Re: St. Lucie Units 1 and 2
Docket Nos. 50-335 and 50-389
Fourth Ten-Year Interval In-Service-Test Program Submittal
RAI Reply to Relief Request PR-04 (TAC No. MD7748)

RAI Reply for Pump Relief Request – PR-04
Low Pressure Safety Injection Pump Group Classification

Equip: 1B LPSI PUMP

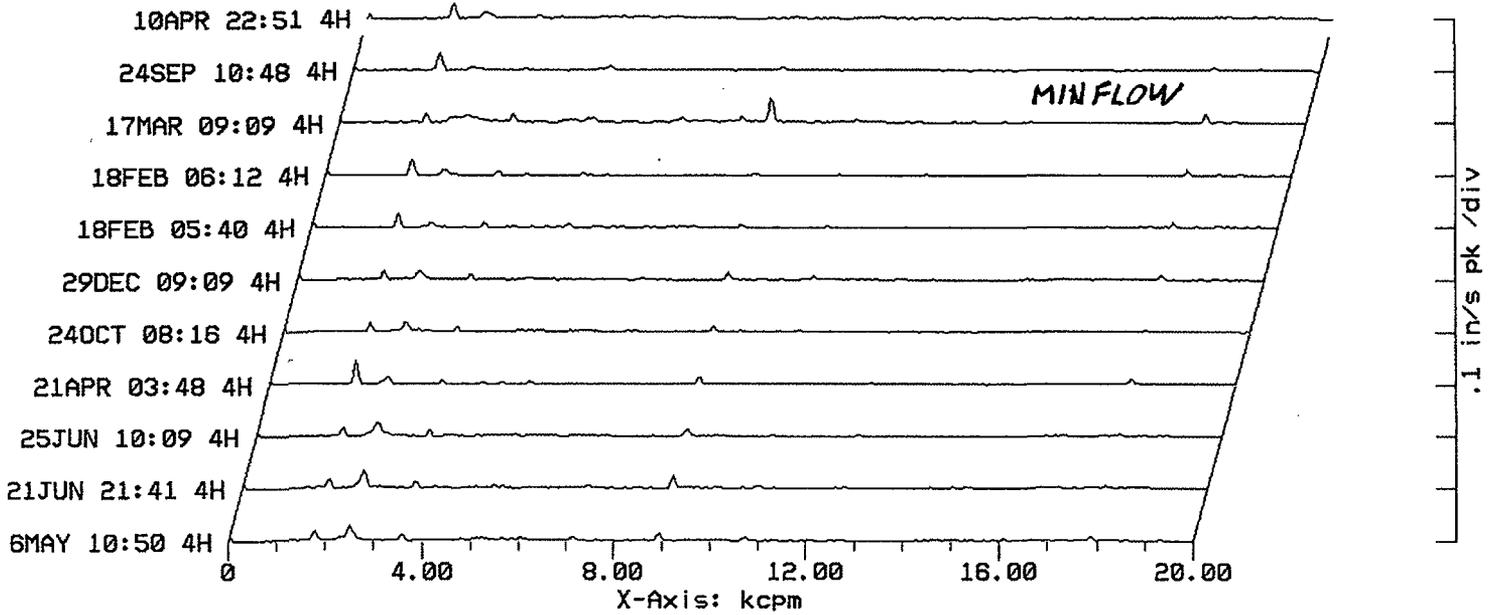
The following information is provided to supplement Relief Request Number “PR-04” submitted by Florida Power and Light Company under FPL Letter L-2007-144. This information is provided based on a telephone conversation between the NRC and FPL on July 2, 2008. Specifically, the NRC requested that the licensee provide basis and details for accepting the higher vibration values of 0.325 in/sec to 0.5 in/sec seen while testing the Unit 1 low pressure safety injection (LPSI) pumps under mini-recirculation flow conditions as described in previous PR-12 during the 3rd 10-year interval IST program. Additionally, the NRC requested that St. Lucie describe additional non-Code monitoring and spectral analysis activities performed on the LPSI pumps under design flow conditions during outages.

The Unit 1 LPSI pumps are included in the plant predictive maintenance (PDM) monitoring program, therefore, many years of spectral analysis and trend data from PDM test results are available for review (Attachments 3 and 4). PDM usually collects data when the pumps run at needed shutdown cooling (SDC) flows, but occasionally data is collected at the Section XI full flow and minimum flow tests. From the spectral patterns it can be seen that, at minimum flow conditions,

both pumps generate increased vibration levels. At low flow, vibration velocity levels at five running speed frequencies (5X), the vane passing frequency, are significantly increased due to elevated vane pass vibration since the water's velocity vector is not striking the volute tongue at the optimal angle. The increased vibration at the 2X frequency is a result of an abnormal pressure distribution in the volute that acts to asymmetrically load the impeller. Also contributing to the overall vibration increase is hydraulic broadband "spectral floor" energy generated by shock energy due to increased turbulence and internal recirculation flow.

As can be seen in Attachments 3 and 4 near BEP, the hydraulic vibration patterns are normal and expected. At lower flows there is increased vane pass (5X) and floor energy. As the flows return to near BEP the vibration patterns and levels return to normal. Therefore, though overall vibration can dramatically increase at low flow conditions, reaching 0.45-0.50 in/sec on these pumps, there is little sign that the pump condition would be degrading.

Bearing defect frequencies are generated from anti-friction (ball) bearings when the bearing surfaces are degraded. These frequencies are not present until a defect forms in the bearing itself. Depending on the specific location of the defect, the rolling elements will strike the defect at a certain frequency driven by the bearing geometry and the rotating speed. The bearing defect frequencies (inner race, outer race, ball, and cage) are normally calculated and compared to any spectral frequencies that appear. These frequencies are typically obvious when displayed in the spectral trend format, so changes are quickly apparent. As can be seen in Attachments 3 and 4 there are no bearing defect frequencies that have appeared in the spectrums.
